NORTHERN STATES POWER COMPANY

PRAIRIE ISLAND NUCLEAR GENERATING PLANT
Docket No. 50-282 License No. DPR-42
50-306 DPR-60

Additional Information Related to
Prairie Island License Amendment dated December 29, 1978

FIGURE B1

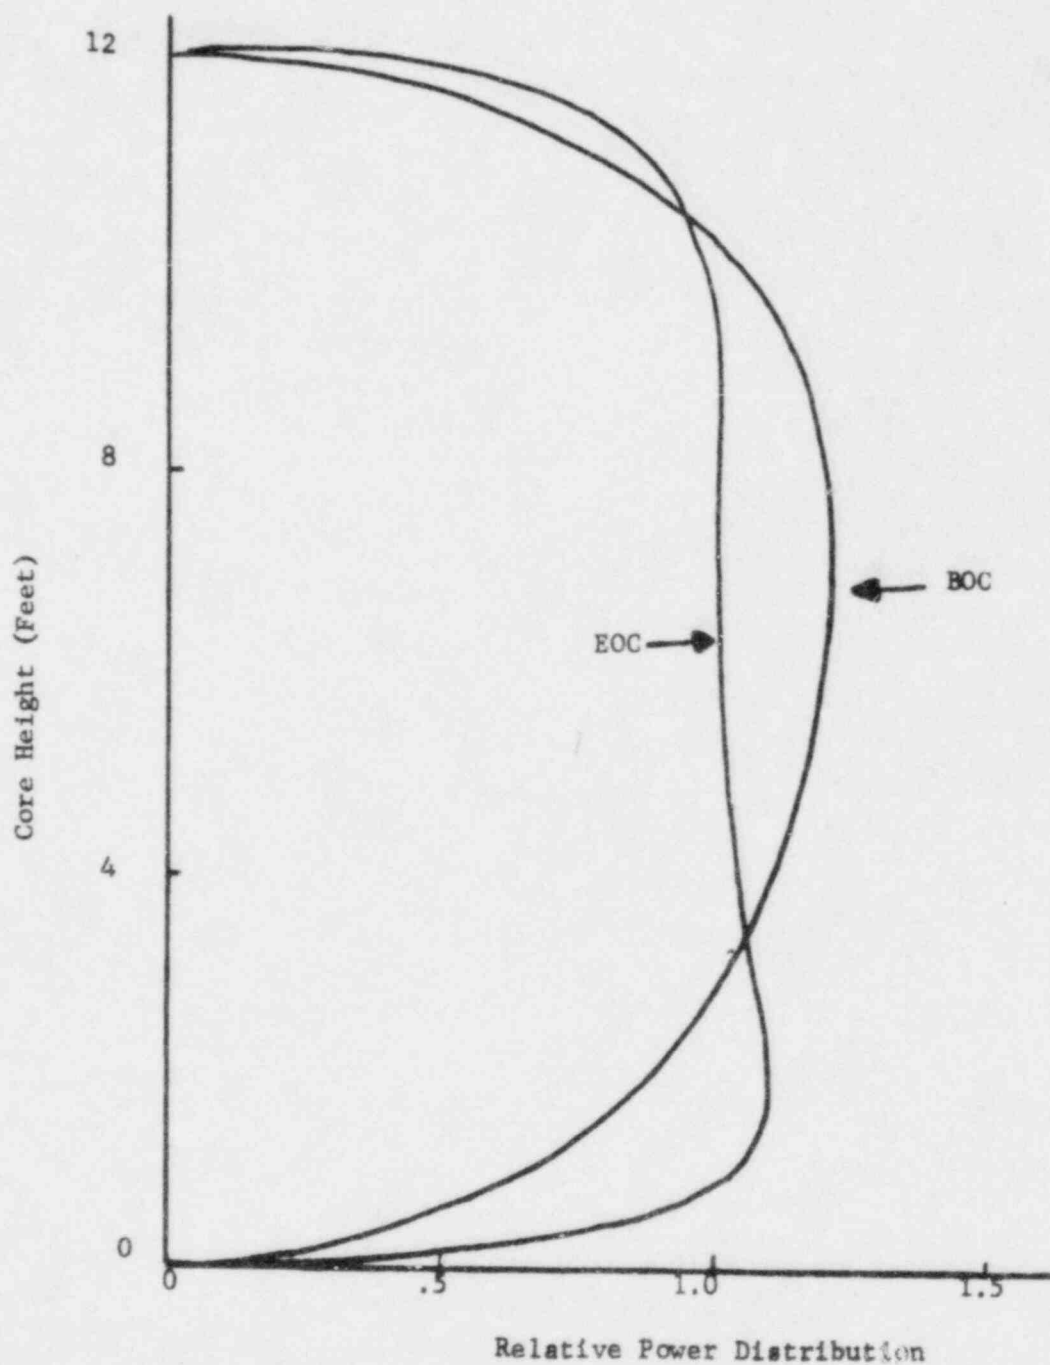
The moderator temperature coefficient has been predicted to become negative at >70% power. A test will be conducted at a power greater than 70% to confirm the design prediction. This test will be conducted at a stable xenon condition.

Figure B1 illustrates the predicted axial power distribution for the hot full power BOC (0 MWD/MTU) and EOC (11 300 MWD/MTU).

HOT CHANNEL FACTOR NORMALIZED
OPERATING ENVELOPE FOR $F_Q = 2.21$

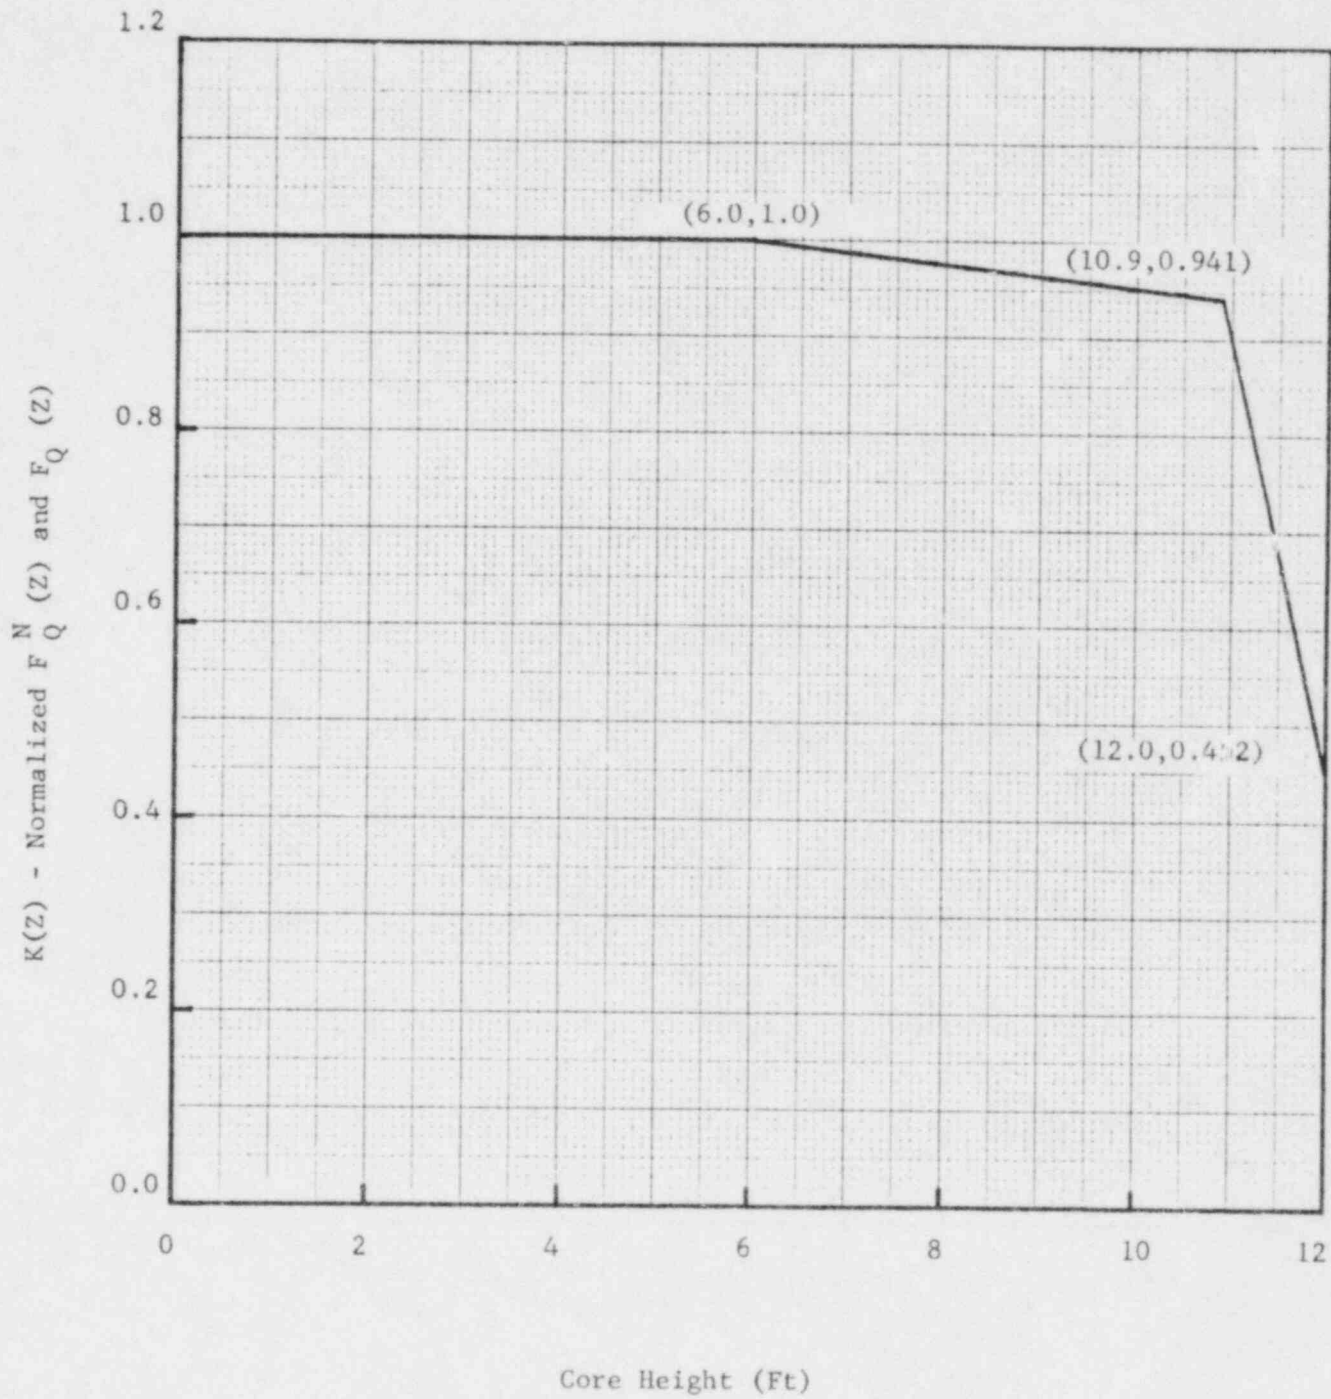
- (1) Monthly confirmation of $F_Q^N(Z)$
- (2) Definition of equilibrium condition and conditions for which monthly confirmation is to be conducted
- (3) Setting - 3% as the target ΔI at EOC
- (4) Revision of $V(Z)$ curve based on analytical data
- (5) Confirmation of $F_Q^N(Z)$ at the highest appropriate power
- (6) Revision of $K(Z)$ curve specifically for F_Q of 2.21

- (1) P is the fraction of full power at which the core is operating
- (2) K(Z) is the function given in Figure TS.3.10-5
- (3) Z is the core height location of F_N
